California MLPA Master Plan Science Advisory Team
Summary of SAT Water and Sediment Quality Evaluation of Round 2
NCRSG Draft MPA Proposals for the MLPA North Coast Study Region
Revised June 21, 2010

Overview of MPA Proposal Evaluations Regarding Water and Sediment Quality

Figure 1. Weighted scores for all water-quality evaluation categories in a given proposal

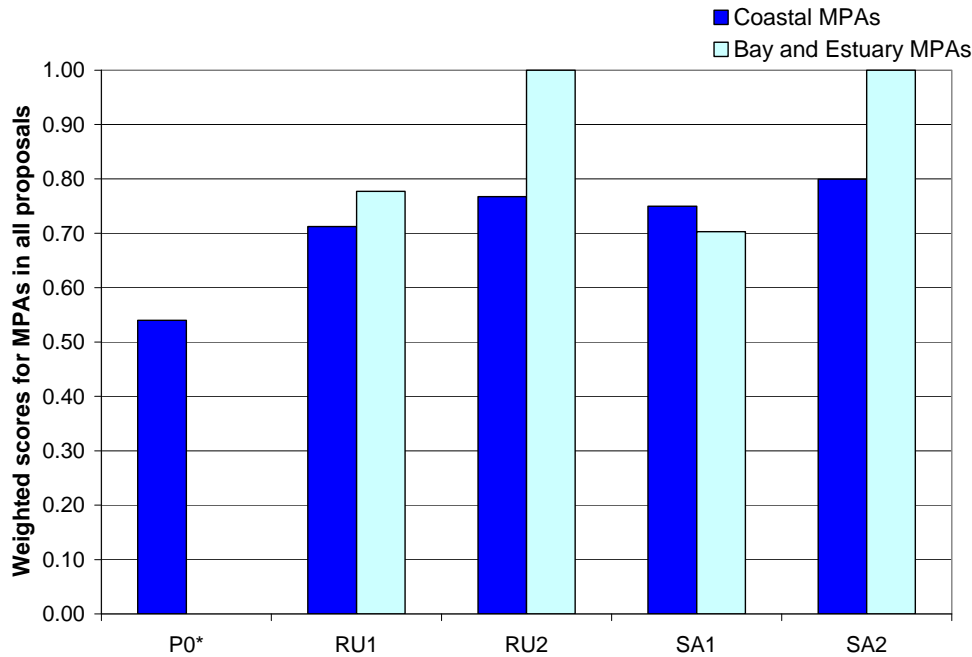
All submitted proposals scored very well for coastal MPAs, with proposal weighted scores greater than 0.67 (Figure 1). However, the difference between the highest and lowest scores was minimal. There was only one MPA (MacKerricher State Marine Conservation Area [SMCA]) that overlapped partially with an urban stormwater discharge area (Fort Bragg municipal separate storm sewer system [MS4]) draining into it. This MPA was found in both Ruby 1 (RU1) and Sapphire 1 (SA1) and the Fort Bragg MS4 drainage area reaches only the southern portion of both MPAs. Of the four proposals submitted for evaluation, Sapphire 2 (SA2) had the most favorable coastal MPAs scores (weighted score 0.80) followed by Ruby 2 (RU2) (weighted score 0.77), Sapphire 1 (weighted score 0.75) and Ruby 1 (weighted score 0.71). Scores were mostly influenced by the co-location with ASBSs and the number of MPAs proposed in a given proposal, rather than the co-location in areas of water quality concern. Interestingly, all of the submitted proposals scored better than Proposal 0, with a weighted score of 0.54.

Figure 2. Weighted scores and the associated water quality concerns for all Round 2 proposals with bay and estuary MPAs

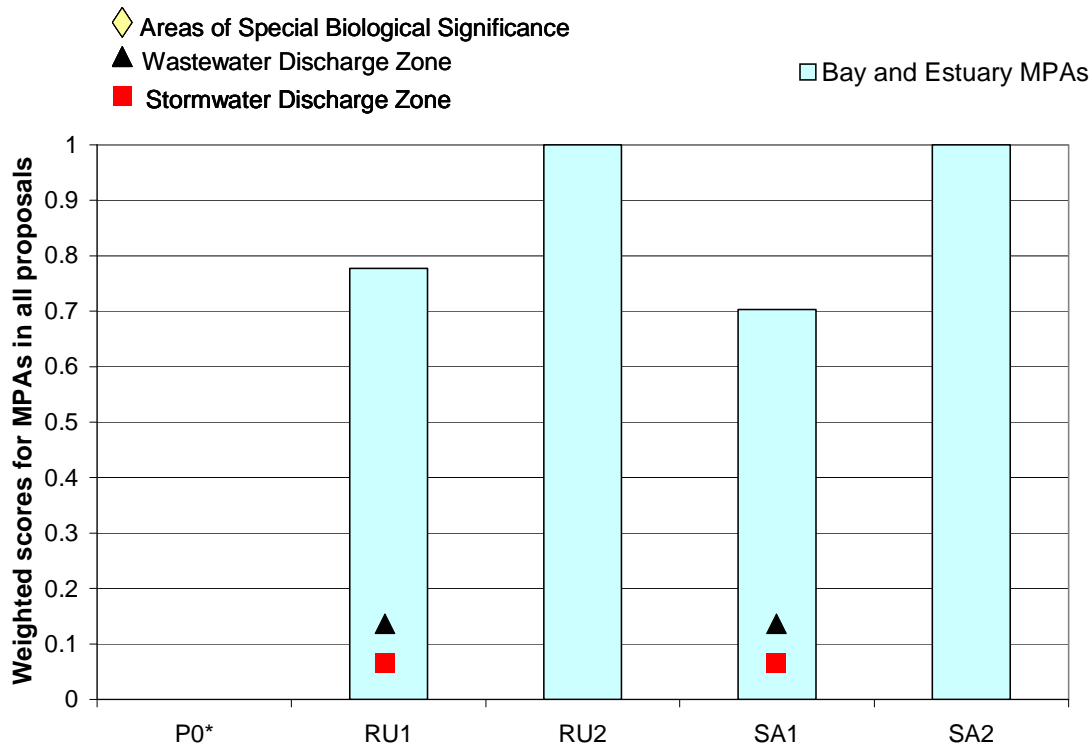
Proposals Ruby 2 and Sapphire 2 scored very well (weighted scores 1.0) and neither proposal contained MPAs that were located in areas where available data indicated water quality concerns. Proposals Ruby 1 and Sapphire 1 scored lower (weighted scores 0.78 and 0.70 respectively) than the other two but still scored well. Both Ruby 1 and Sapphire 1 contain an MPA in North Humboldt Bay (North Humboldt Bay State Marine Recreational Management Area [SMRA]) which has water quality concerns. There is an intermediate wastewater discharge outfall operated by the city of Arcata in the northeast portion of the bay. In addition to this, the North Humboldt Bay State Marine Recreational Management Area (SMRMA) is adjacent to an urban stormwater discharge area (Arcata MS4). Both of these factors contribute to the decreased score for North Humboldt Bay SMRMA in both proposals Ruby 1 and Sapphire 1. All other bay and estuary MPAs in Ruby 1 and Sapphire 1 were free of water quality concern areas as defined by the SAT.

Figure 3. Proposal 0: Scores for coastal MPAs with water quality concerns and opportunities and the proposal's average score

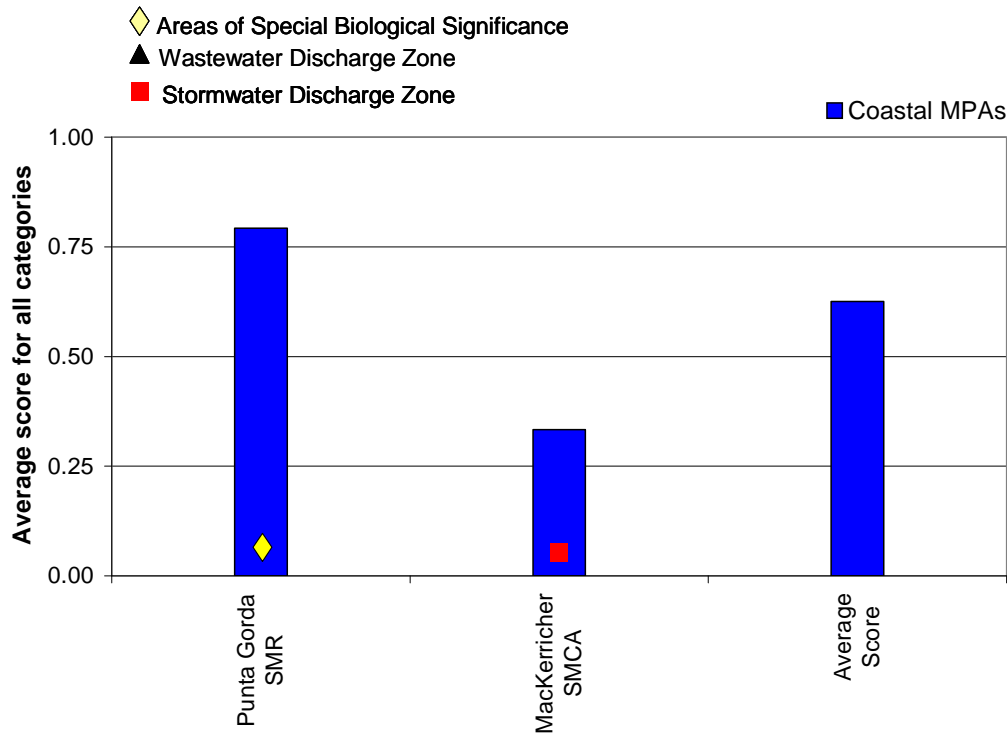
Proposal 0 comprises the five existing MPAs. All five MPAs are located along the coast. The average score for existing coastal MPAs is 0.63 and the weighted score is 0.54 (Appendix A). Four of the five coastal MPAs (80%) scored 0.67 or higher. Also, one of existing MPAs is co-located within an ASBS (Figure 3). Only one out of five coastal MPAs scored lower than 0.67 (located within urban stormwater discharge drainage area (Fort Bragg MS4) near MacKerricher State Park) (Figure 3).

Figure 4. Ruby Draft MPA Proposal 1: Scores for coastal MPAs with water quality concerns and opportunities and the proposal’s average score

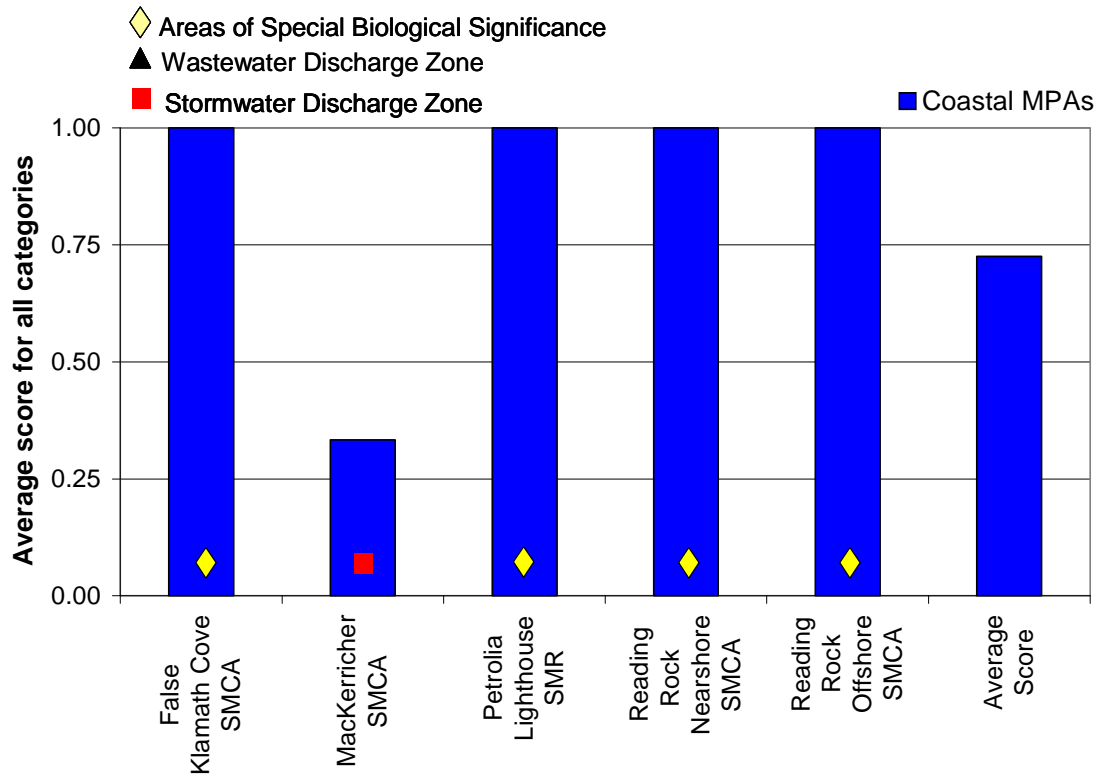
Nearly 83% of the Ruby 1 MPAs located in bays and estuaries scored well (1.00); only one of six MPAs located in bays and estuaries scored poorly. The Humboldt Bay SMRMA was co-located adjacent to Arcata’s urban stormwater discharge areas and scored a 0.25. Additionally, this MPA was also co-located with an intermediate wastewater discharge outfall operated by the city of Arcata in the northeast portion of the bay. There are also aquaculture activities nearby but outside the MPA, which should be considered.

The average score for Ruby 1 coastal MPAs is 0.73 and the weighted score is 0.73 (Appendix B). There were 16 of 17 (94%) coastal MPAs that scored 0.67 or higher. There were also 4 of 17 coastal MPAs that were entirely co-located within an ASBS (Figure 4). Three of these MPAs were co-located within Redwood National and State Park ASBS. The fourth MPA was co-located within the Kings Range National Conservation Area ASBS. Only one coastal MPA scored lower than 0.67 (MacKerricher SMCA). The MacKerricher SMCA was located within an urban stormwater discharge drainage area near MacKerricher State Park in Fort Bragg. A potential solution to improving the MacKerricher SMCA’s score would be to move the boundary north of the urban stormwater discharge drainage area.

Figure 5. Ruby Draft MPA Proposal 2: Scores for coastal MPAs with water quality concerns and opportunities and the proposal’s average score

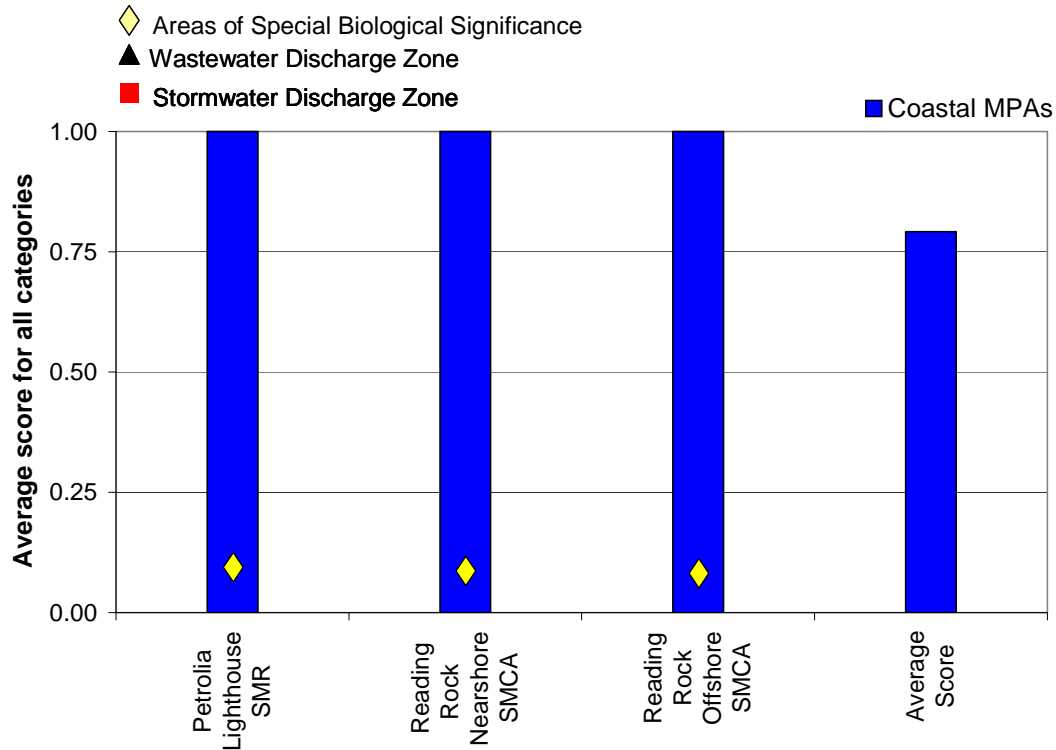
All four MPAs proposed in Ruby 2 located in bays and estuaries scored the highest score of 1.00. There were no MPAs located in areas that had SAT defined water quality concerns per SAT guidelines.

The average score for Ruby coastal MPAs is 0.79 and the weighted score is 0.77 (Appendix C). All eight coastal MPAs scored 0.67 or higher and did not have any water quality concerns associated with them. Furthermore, 3 of 8 (38%) coastal MPAs are entirely co-located within the boundaries of an ASBS and received the highest average score of 1.00 (Figure 5). Two of these MPAs were co-located within Redwood National and State Park ASBS. The third MPA was co-located within the Kings Range National Conservation Area ASBS. There were no coastal MPAs located in areas that had SAT defined water quality concerns per SAT guidelines.

Figure 6. Sapphire Draft MPA Proposal: Scores for coastal MPAs with water quality concerns and opportunities and the proposal's average score

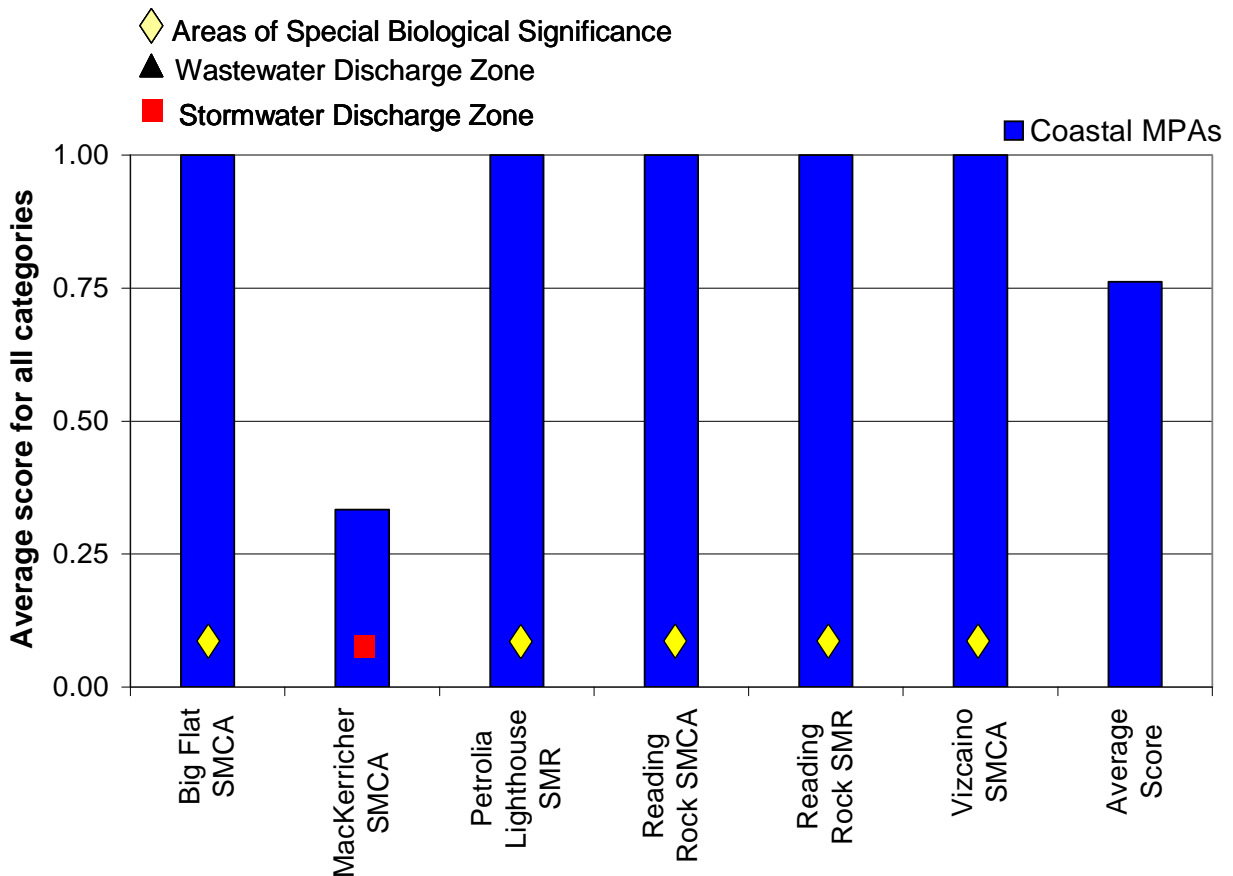
Nearly 83% of Sapphire 1 MPAs located in bays and estuaries scored well (1.00); only one of six MPAs located in bays and estuaries scored poorly. The Humboldt Bay SMRMA was co-located adjacent to Arcata’s urban stormwater discharge areas and scored a 0.25. Additionally, this MPA was also co-located with an intermediate wastewater discharge outfall operated by the city of Arcata in the northeast portion of the bay. There are also aquaculture activities nearby but outside the MPA, which should be considered.

The average score for Sapphire 1 coastal MPAs is 0.76 and the weighted score is 0.75 (Appendix D). There were 13 of 14 (93%) coastal MPAs that scored 0.67 or higher. There were also 5 of 14 (36%) coastal MPAs that were entirely co-located within an ASBS (Figure 6). Three of these MPAs were co-located within Redwood National and State Park ASBS. The fourth and fifth MPA were co-located within the Kings Range National Conservation Area ASBS. Only one coastal MPA scored lower than 0.67 (MacKerricher SMCA). The MacKerricher SMCA was located within an urban stormwater discharge drainage area near MacKerricher State Park in Fort Bragg. A potential solution to improving the MacKerricher

SMCA's score would be to move the boundary north of the urban stormwater discharge drainage area.

Figure 7. Sapphire Draft MPA Proposal 2: Scores for coastal MPAs with water quality concerns and opportunities and the proposal's average score

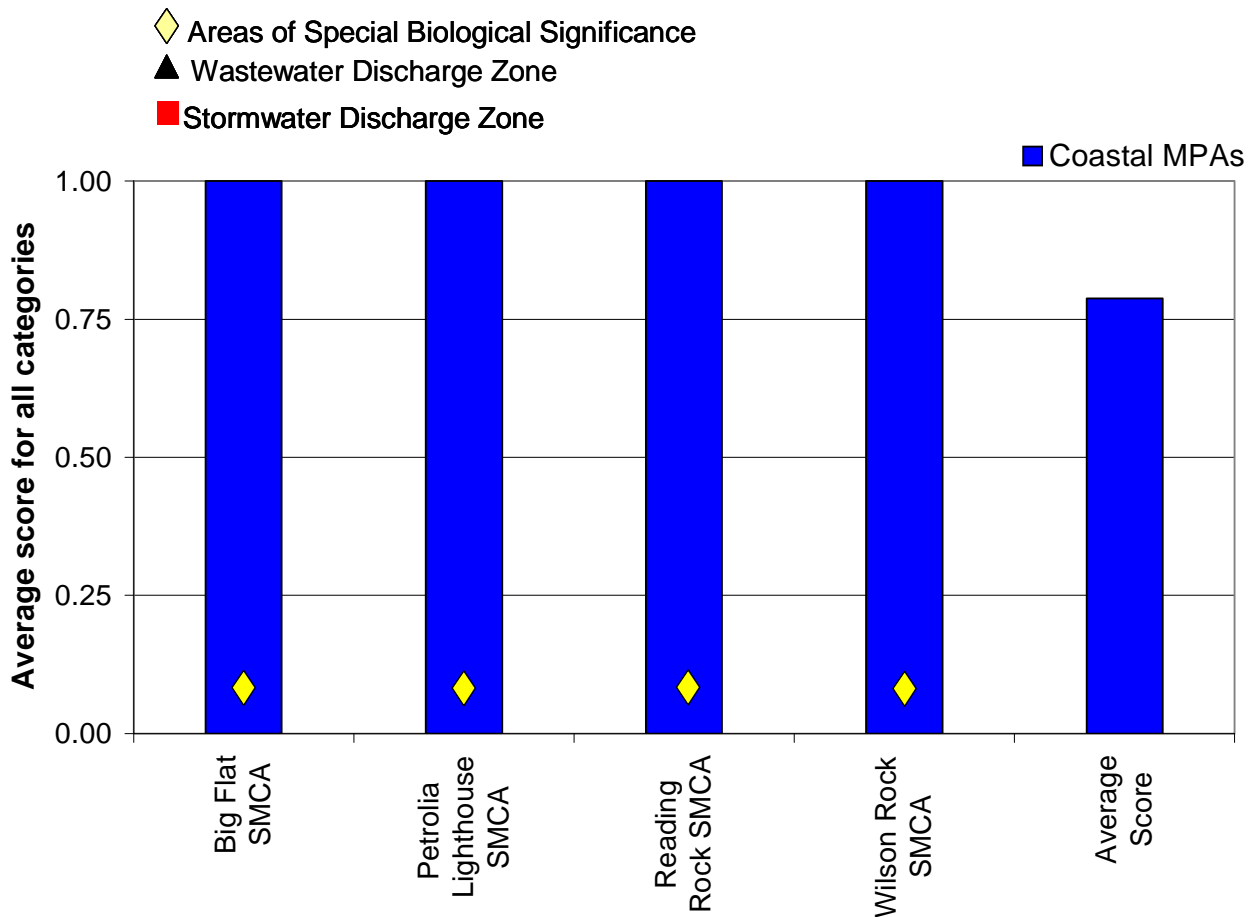
All three MPAs proposed in Sapphire 2 located in bays and estuaries scored the highest score of 1.00. There were no MPAs located in areas that had SAT defined water quality concerns per SAT guidelines.

The average score for Sapphire 2 coastal MPAs is 0.79 and the weighted score is 0.80 (Appendix E). All 11 coastal MPAs scored 0.67 or higher and did not have any water quality concerns associated with them. Furthermore, 4 of 11 (36%) coastal MPAs are entirely co-located within the boundaries of an ASBS and received the highest average score of 1.00

(Figure 7). Two of these MPAs were co-located within Redwood National and State Park ASBS. The third and fourth MPAs were co-located within the Kings Range National Conservation Area ASBS. There were no coastal MPAs located in areas that had SAT defined water quality concerns per SAT guidelines.
